TECHNICAL BULLETIN

Bollettino / Bulletin n. BT 3/3.0/2000

AQUA IONIC PLUS anti-disturb filter

Toroide placed on power cable

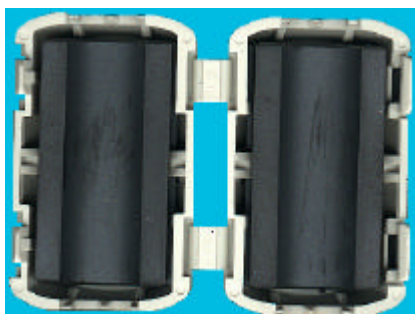
In order to increase immunity to alimentary disturbs, particularly in case of industrial installations we have provided the AQUA IONIC PLUS CONTROLLER with a Toroide to be placed (as show in the picture) on the power cable .

This operation allows a reduction of disturbs due to external connection of the controller.

The Toroide will be available on our controller starting from the next shipments. As spare part you can purchase it with the part number: 96-F Please do not hesitate to contact us for any further information you may need.
